USB3.0 Hub Controller

(Ver 5.0)

This document describes the notification of μPD720210, USB 3.0 Hub controller.

PCN Tracking Number : SAG-B-14-0008

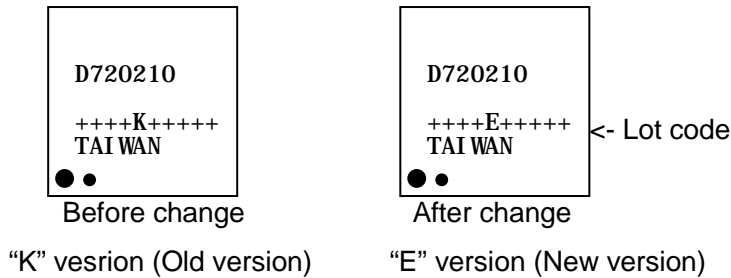
This item is the supplement for the following PCN (Product Change Notice).

This change enables the elimination of external SPI ROM. Systems using the current version with external SPI ROM are not affected by replacing the version with this change, because the functionality of these versions will be identical, in the case where they are used with the external SPI ROM.

Changing 5th character of lot code by each plant as below. (Before change : K, after change : E)

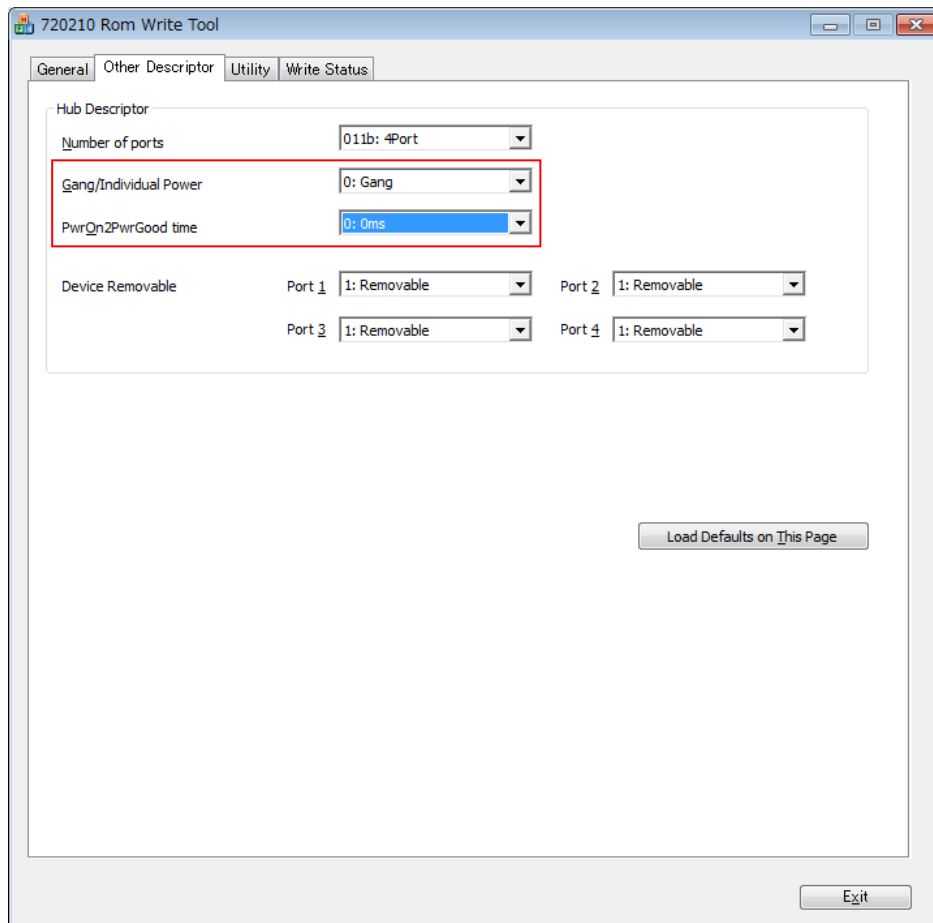
- If using FW Version 1.0.2.3 -008 or later, use the external SPI ROM.
- If the design needs to support "Gang mode without power switch", use the external SPI ROM. (Refer to Notification : 20140213-1 in this document.)
- Use the ROM writing tool for Windows : Version 1.4.0.0 or later.

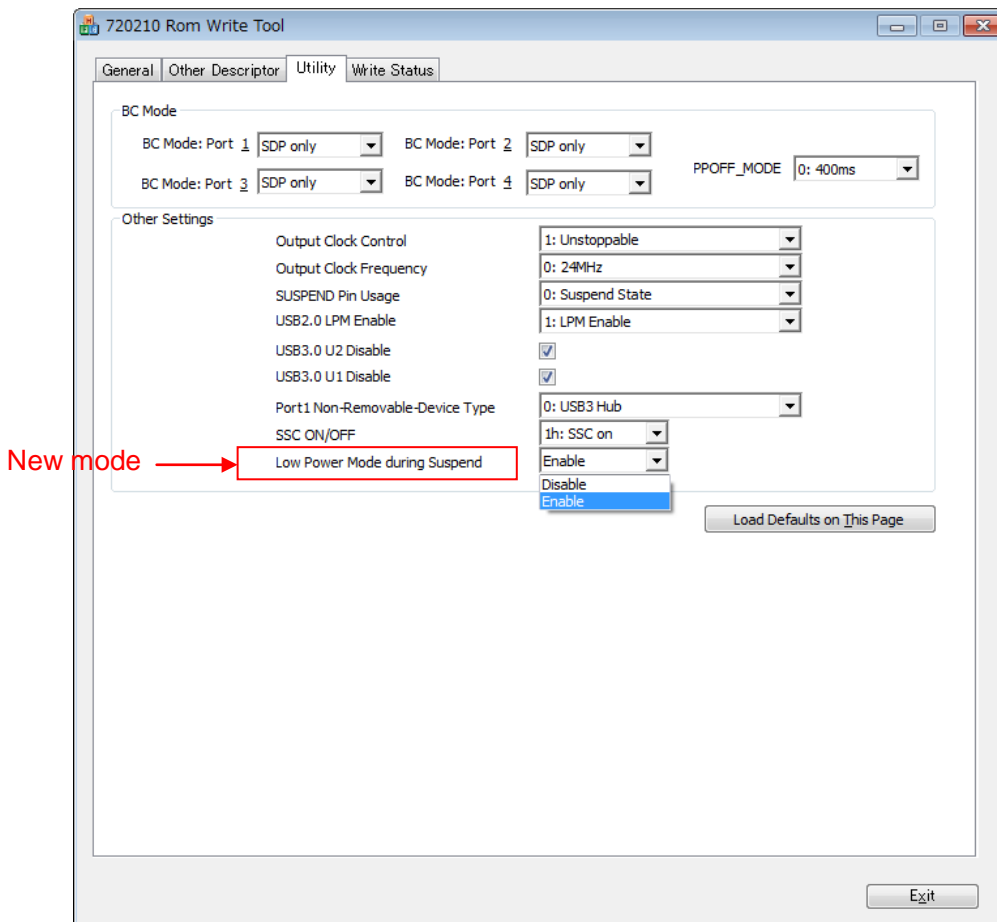
Some non-compliant USB 3.0 devices that are connected to uPD720210 cause the interoperability problem that they are not recognized to the PC after hibernation and resume when uPD720210 is used in the gang mode and VBUS on its downstream port is not controlled by a power switch. Those devices seem to have the restriction that they go out of control when detecting the disconnection of the far-end Rx termination while keeping VBUS.

1. This problem is fixed by updating FW. Please update with FW Version 1.0.2.3 - 008 or later when the product supports the gang mode without power switch. Note that this workaround is enabled only when Gang/Individual Power is "0: Gang" and PwrOn2PwrGood time is "0: 0ms" in the uPD720210 ROM Writing Tool for Windows. And when this workaround is enabled, "Low Power Mode during Suspend" is forcibly disabled and power consumption is higher than when this workaround is disabled due to enabling the Rx termination.

2. Or, use a power switch in gang mode. In this case, PwrOn2PwrGood time should be "1: 100ms" in the uPD720210 ROM Writing Tool
